U.S. Department
Of Transportation
**Federal Highway
Administration**

May 11, 1989

Refer to: HNG-14/SS-10

This is in response to Mr. Red Lindsay's February 15 letter to Mr. Thomas O. Willett requesting acceptance of your company's 3-inch diameter fiberglass signpost system. You provided additional information on March 20 in response to our request. Together, these submissions include reports of two tests conducted by the Texas Transportation Institute, a specification for fiber-reinforced plastic (FRP) small sign supports, and supplementary information on component specifications.

Figure 1. Details of sign installation for test 0366-1.

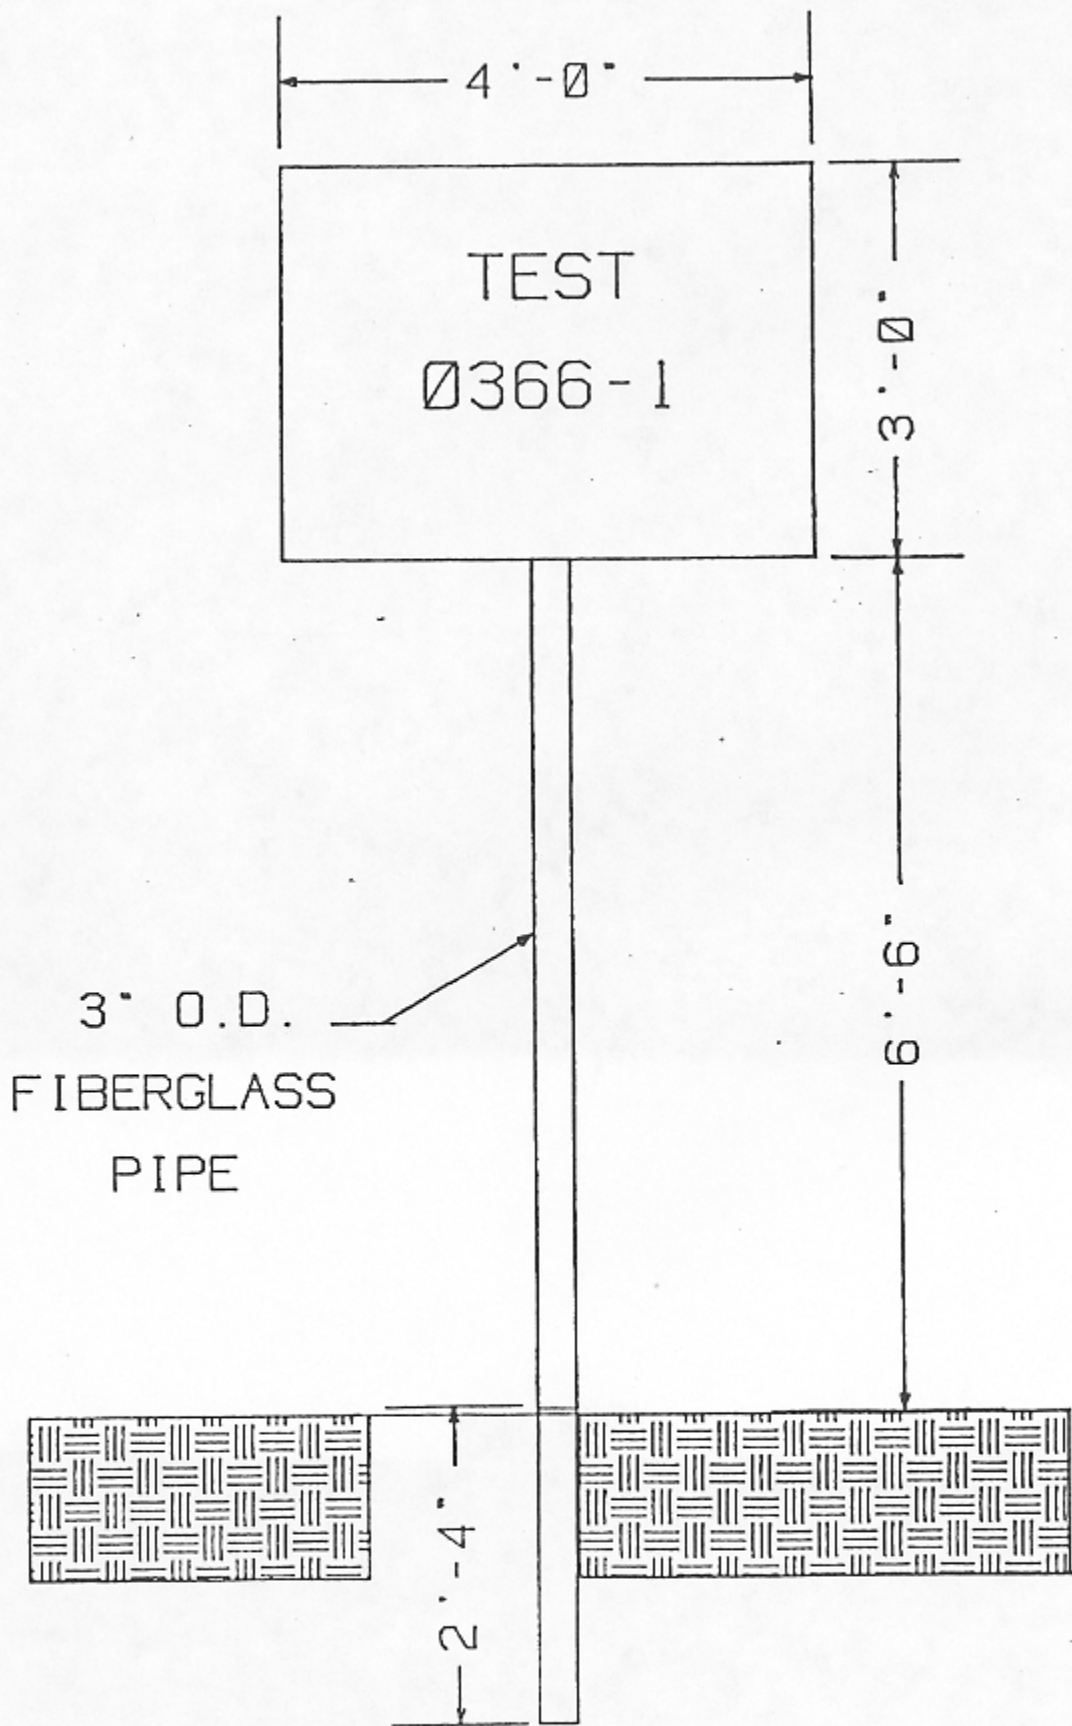
The sign post system consists of a 3-inch outside diameter FRP post composed of polyester resin (Owens-Corning Fiberglass) OCF E-440 Type Orthophthalic) and glass fiber reinforcement (OCF Roving 113, Yield T-30 or equivalent). The fiber-reinforced tube is manufactured by a process called "pultrusion", whereby longitudinal and diagonal glass fibers are combined with a resin. A surface veil of woven glass fiber completes the 1/8-inch thick wall of the tube. This FRP post is inserted into a 28-inch long, 3.10-inch to 3.125-inch inside diameter ceramic coated steel tube (wall thickness of 0.062 to 0.095 inches) which has been flattened for 12 inches to prevent rotation. Self-tapping screws secure the post in place.

Based on the above information this signpost system is acceptable for use on Federal-aid highway projects, should its use be proposed by a State. This acceptance is limited to breakaway characteristics of the system described above and does not cover its structural features. Further, we have determined that only one post should be allowed within an 8-

foot path. We note this system was only tested in the strong (S-1) soil described in NCHRP 230. Usually we would suggest that breakaway supports be tested in weak (S-2) soil. However, with the short foundation embedment specified for your support, we consider this additional testing unnecessary. On the other hand, users should be cautioned not to use the support in weak soil if to do so requires an increase in foundation embedment or other revision in the foundation, unless the revised design is tested. Presumably, Hwycor Corporation will supply potential users with sufficient information on structural design and installation requirements to ensure proper support performance.
